DRAWING NAME/DESCRIPTION: DECAL KILO BACK

DRAWING NUMBER: 66-3018-052-XXX

REVISION: B

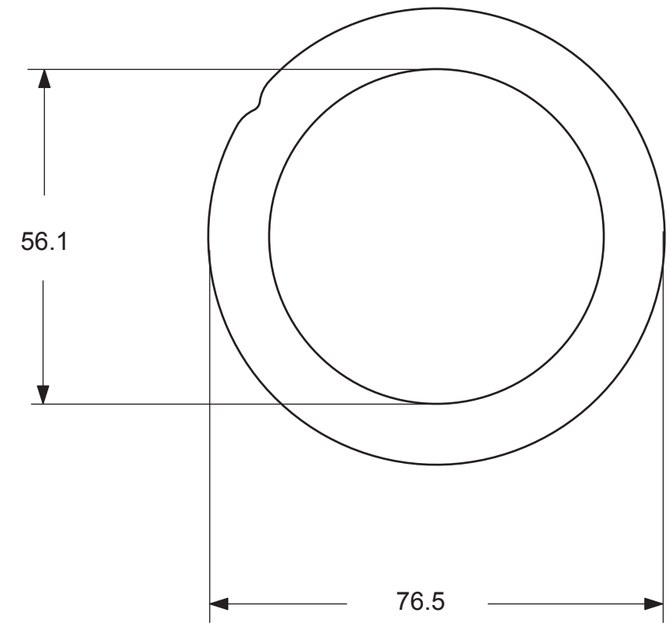
REV	REVISION RECORD
A	RELEASE
B	CHANGE: 76.5 WAS 76.0 (D8), 56.1 (C6) WAS 56.0, ARTWORK, DIE LINE AND SUBSTRATE (NOTE 3)
